**HUGHES
SERVICE INFORMATION
NOTICE**

NOTICE NO. HN- 89

SUBJECT: Modification - Tank Unit Fuel Quantity Rheostat,
PN 369A4245-501 (Kit No. M50047)

MODELS AFFECTED: Model 369H Helicopter Serial No. 0001H thru 0005H
Model 369HE Helicopter Serial No. 0101E and subsequent
Model 369HM Helicopter Serial No. 0001 thru 0004, 0005M
and subsequent
Model 369HS Helicopter Serial No. 0001S thru 0750S; 0761S.

Figure 1. Rework of Tank Unit Fuel Quantity Rheostat,
PN 369A4245-501 Modification Kit No. M50047

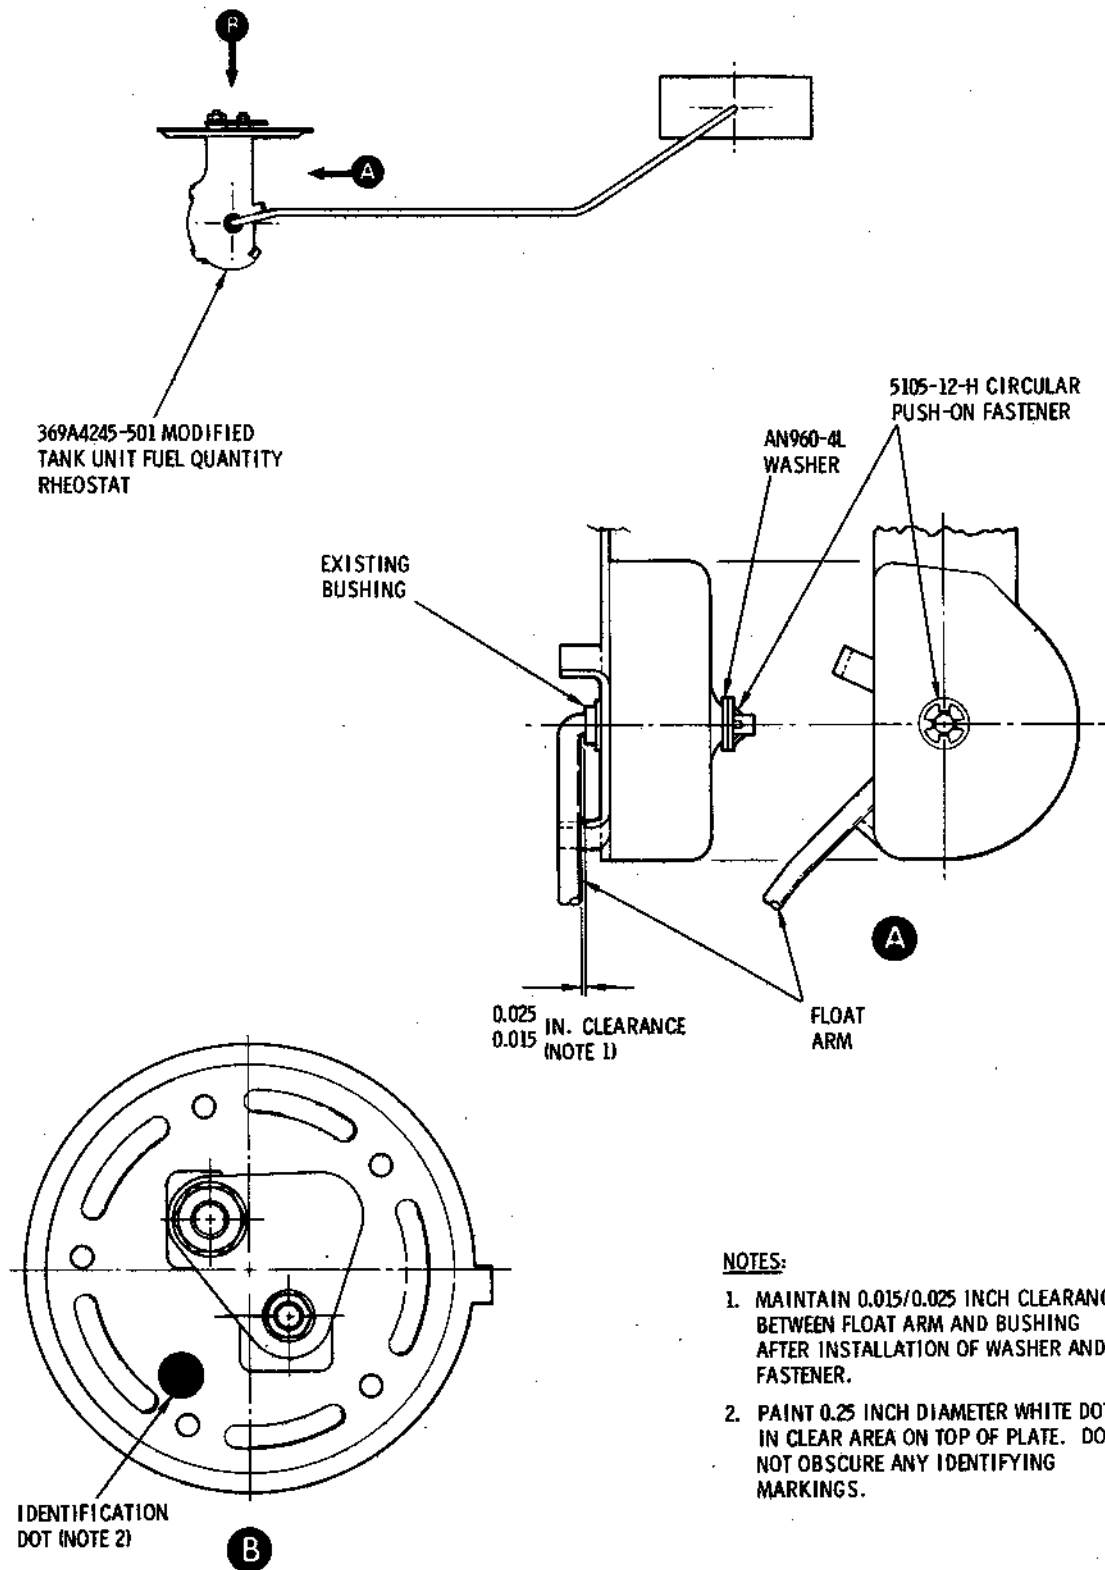
PREFACE: The information given in this Service Information Notice lists a procedure for modifying the fuel quantity rheostat tank unit by installing a retaining ring on the float arm to limit shaft end play, and thus maintain adequate clearance through full travel of the float arm.

- b. Remove left fuel cell access door. (Refer to Basic HMI.)
- c. Disconnect tank unit harness electrical plug from mating connector at fuel shutoff cable support bracket.
- d. Cut lockwire and remove five bolts and washers from tank unit and lift unit from fuel cell cover plate. Discard existing gasket.
- e. Modify tank unit by installing washer and fastener at end of float shaft, as shown in Figure 1; check for 0.015/0.025 inch clearance between float arm and existing bushing after installation of washer and fastener.
- f. Check float and arm for freedom of movement between stops, and float arm for sufficient off-set so that float will clear edge of cell sump and allow full travel of arm.

g. Paint 0.25 inch diameter white dot in clear area on top side of tank unit plate, as shown. White dot identifies reworked tank unit.

h. Install new 369A4518 gasket, modified tank unit with float inboard, washers and bolts. Torque bolts to 50 to 70 inch-pounds. Lockwire boltheads (three and two) together.
